Subject: Chamber Construction Manual
Posted by [Clemens Adler](#) on Thu, 25 Mar 2004 08:24:30 GMT
[View Forum Message](#) <> [Reply to Message](#)

I updated the chamber construction manual (to version 1.1).

1) [image001.gif](#), downloaded 2371 times

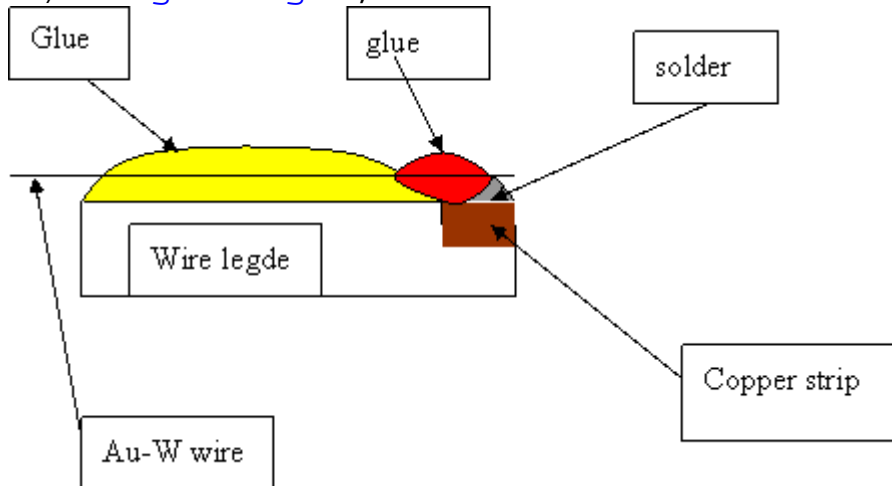
2. An suggestion: Oleg suggests to put some glue to between the glue which holds the anode wire on the wire ledge and the copper strip where the wire is soldered (see attached picture by Oleg).

This should prevent the breaking of the anode wire that we experienced at Heidelberg (see previous messages).

"after soldering of anode wires we put glue (red color) to fix the wire, solder and copper

strip together. It is need to remember that we have to safe a clean place on the copper strip to solder HV cable."

We also had this idea and did it on some chambers, but after discussion with Joerg at GSI, who never had any similar problem we thought that probably sanding the wire ledge edges is good enough and will solve the problem.

Another problem was that we wanted the glue to be cured before we cut the wires, and then we loose 1 day. This is probably not so critical, since at least in Heidelberg and Dubna where not too many people are involved in cahmber building one can find something else to do during this day.

So I would like to hear from GSI (Joerg) and Bukarest (Mihai) what they think. Since we have not put anodes on a chamber since a while due to technical difficulties with machiniery in our lab, I cannot tell at this moment what our experiences with sanding the wire ledges are. I will, therefore, not add this into the construction manual, until there are some more opinions about this additional step.
